TSB41BA3 Errata

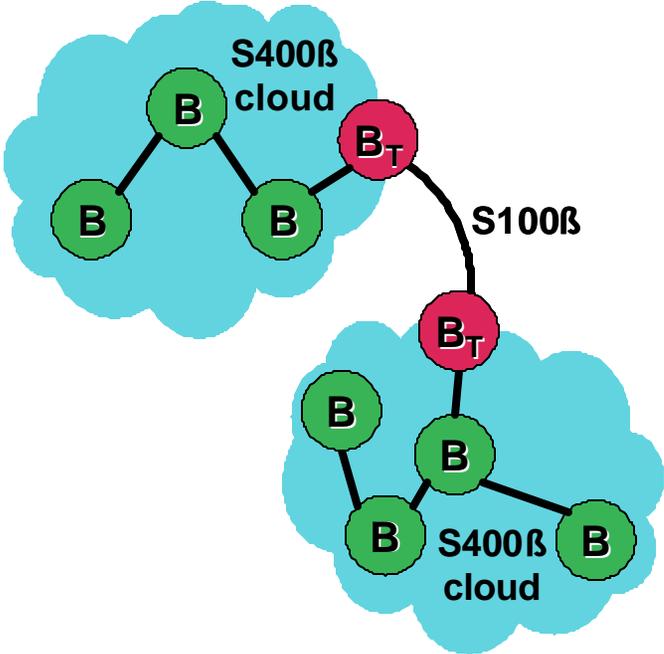
ERRATA ID	PROBLEM DESCRIPTION	RESOLUTION / WORK-AROUNDS
	<p>B) Mixing bus hop speeds. Either transition node (“B_T”) may have a BOSS arbitration issue:</p>  <p><u>Detailed Example Situation</u> Refer to the diagram below.</p> <ol style="list-style-type: none"> 1. Node #2 transmits a high-speed packet that ends an Async Subaction or the Isoch period. 2. Node #2 advances the Async phase (no requests pending for the current phase). 3. Node #0 has a bus request pending for the new phase. 4. Node #2 sends an Async grant.

ERRATA ID	PROBLEM DESCRIPTION	RESOLUTION / WORK-AROUNDS
	<p>5. The Async grant is forwarded through a senior node (Node #1) and down through a junior connection to Node #0.</p> <p>6. If a narrow timing window is violated, then the middle node (Node #1) will detect a packet collision, causing a state-timeout while forwarding the grant to the next node. The state-timeout will cause a bus reset.</p> 	
<p>2. Missing Subaction Gap Issue</p>	<p><u>Symptom</u> When nonroot 1394b nodes request transactions and do not receive an Ack (missing-Ack timeout occurs) the 1394b Link Layer is only sent an Arbitration Reset gap indicator rather than a both the Subaction gap and Arbitration Reset gap indicators. Some Link Layer controllers hang if the Subaction gap indicator is not received.</p> <p><u>Occurrences</u> This does not occur with TI Link Layers and has only been observed by one other Link Layer manufacturer.</p>	<p>Instruct the Link Layer Controller to use 1394a mode for the PHY-Link interface.</p>
